July 21, 2020

PEBBLE FINAL EIS -- A NEPA PROCESS STILL OFF-TRACK

PLP Figure I-5, Diamond Point Port and Lightering Location (May 2020)

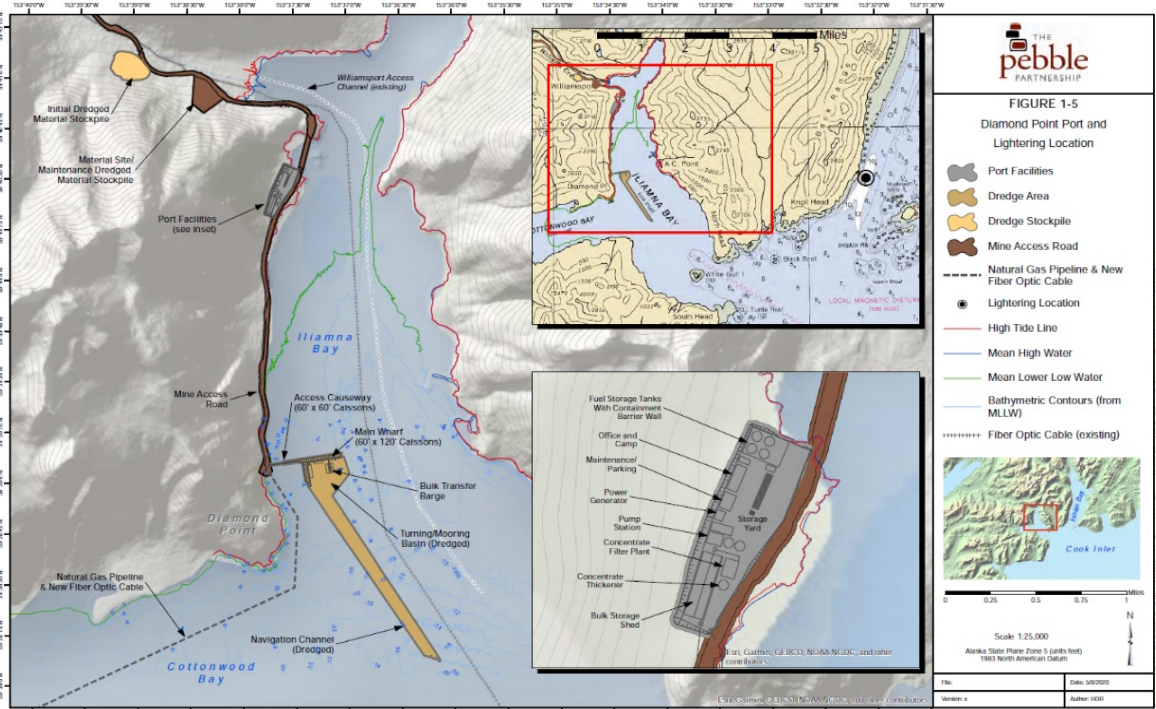
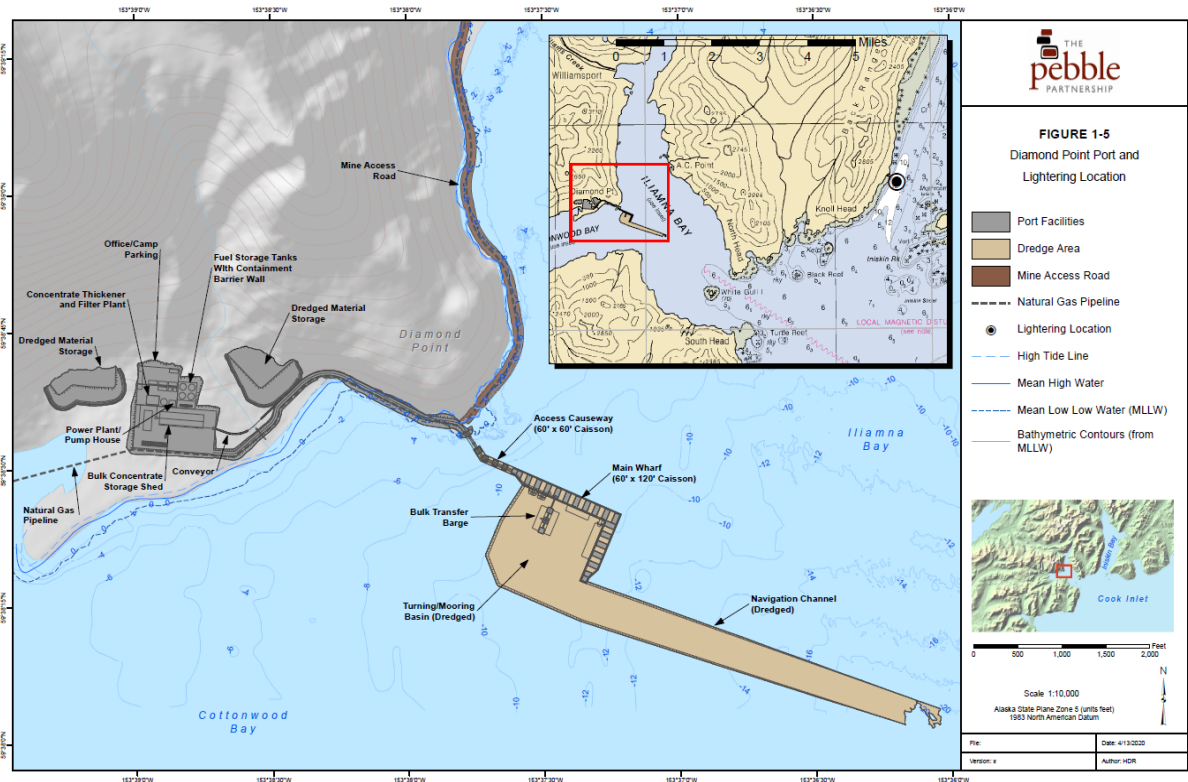
PLP documents from May 2020 reveal that while PLP has kept the name of the port the same – “Diamond Point Port and Lightering Location” -- all key elements of the port have now changed. For example, the Port Facilities were moved from Cottonwood Bay to a location deep inside Iliamna Bay. The Main Wharf was also moved from the mouth of Cottonwood Bay north into Iliamna Bay. These [project components are now illustrated as follows:](#)

The dredged material will be placed into two bermed stockpiles located in uplands adjacent to the port facility. Consolidation and runoff water would be channeled into a sediment pond and suspended sediments would be allowed to settle before discharge to Iliamna Bay. [...] The channel will be approximately 2.9 miles in length and 300 feet wide (3 times the maximum expected barge width), while the turning basin will incorporate an area of approximately 1,100 feet by 800 feet. The total volume of dredged material for the initial dredging is estimated at 1,100,000 cubic yards. Maintenance dredging (estimated at 20 inches every 5 years) is expected to total 700,000 cubic yards over twenty years (four times).

Furthermore, PLP's May 2020 Project Description includes a new "dredging plan" that was not disclosed in the Draft EIS. Dredging has offshore and onshore impacts (due to placement of dredged materials onshore), none of which were analyzed in the Pebble Draft EIS.

Turning back to the July 20 Corps Media Briefing, the Corps was specifically questioned as to whether the port site in the new preferred alternative is different from what was considered in the earlier EIS documents. David Hobbie, unequivocally, said no. See [recording at 11:45 and again at 27:20](#). As detailed above, this answer is not true.

The appropriate course of conduct for the Corps when faced with a change of this magnitude is to revise the Draft EIS and allow opportunity for public review and input of the changes. Doing so would include consulting with the neighboring landowners to seek their input on how the proposed changes to the port facilities may impact their property, and uses of their property, including business uses. This has not been done. Notably, BBNC has a business interest in the neighboring Diamond Point quarry, through the aptly-named Diamond Point, LLC.
